**Subject: Infiltration/Injection Temporary Exemption Request
Tecumseh Products Co – New Holstein, 1604 Michigan Ave, New Holstein
BRRS 02-08-363333
WPDES Permit Site ID (FIN): 77951**

**Subject: Remedial Action Design Report Review
Tecumseh Products Co – New Holstein, 1604 Michigan Ave, New Holstein
BRRTS 02-08-363333**

PROJECT: BRRTS #02-08-36333		TECUMSEH PRODUCTS CO. (FORMER) - CHROMIUM LINE NEW HOLSTEIN, WISCONSIN	
SHEET TITLE: SOIL MAP			
DRAWN BY: J. PAPEZ	SCALE: 1:720	PROJ. NO. 107927-200-9300	FIGURE 4
CHECKED BY: C. HARVEY	DATE PRINTED:	FILE NO. 107927-200-015.mxd	
APPROVED BY: C. HARVEY	DATE: OCTOBER 2019

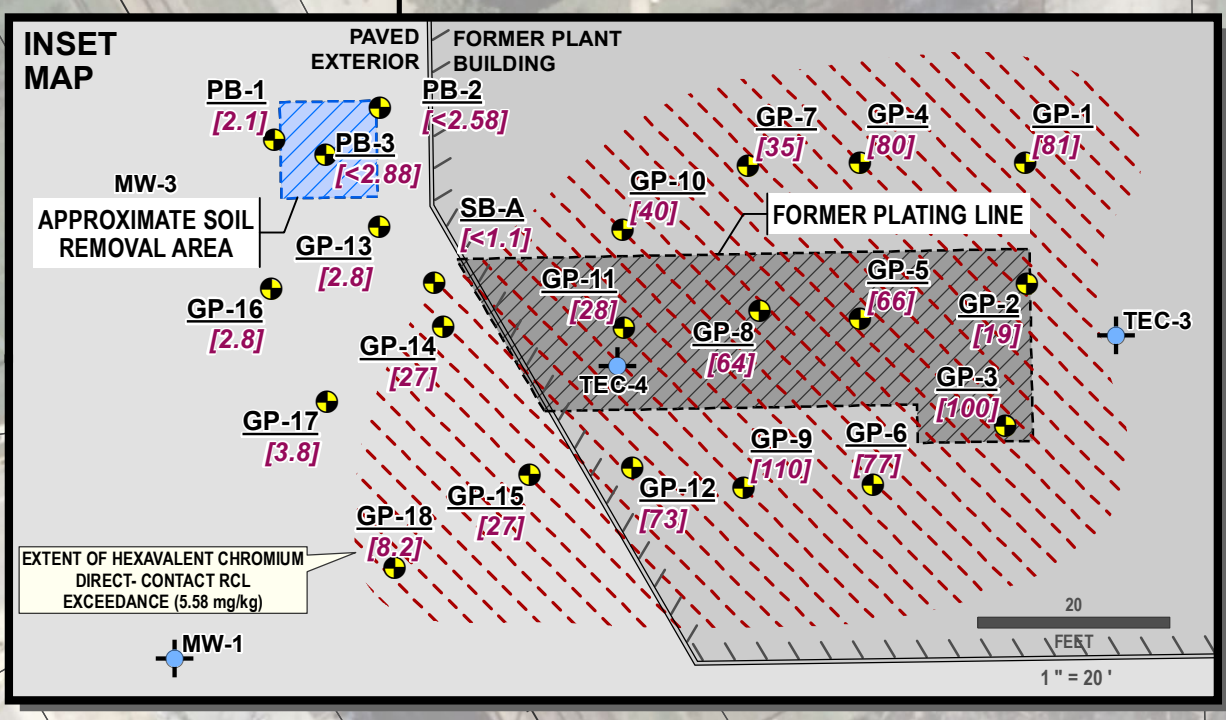
Pre-remediation soil samples should be collected in the northern plating line treatment zone.

We do not believe that additional soil sampling in the former northern plating line area is warranted for the following reasons. There are three soil borings near the former northern plating line area (see attached figure). These soil borings had no results above the NR 720 screening levels for chromium or lead (see the attached analytical summary table). In addition, the purpose of the proposed supplement remedy is to address the residual chromium impacts in groundwater. TRC’s approved remedy does include soil mixing in the unconsolidated soil to address groundwater, targeting potential groundwater fluctuation zones. The approved soil performance standard (SPS) addresses any residual soil impacts, including residual soil impacts for other incidents.

Because soil will be fully mixed in both former plating lines from ground surface to approximately six feet below ground surface (bgs), the approximate deeper depth of the groundwater table, there will be no way to compare results at pre-and post-remedial soil sampling locations. The depth to groundwater at the wells near this area were last measured to be between 2.98 and 6.28 ft bgs. Therefore, pre-remedial soil sampling is unnecessary.
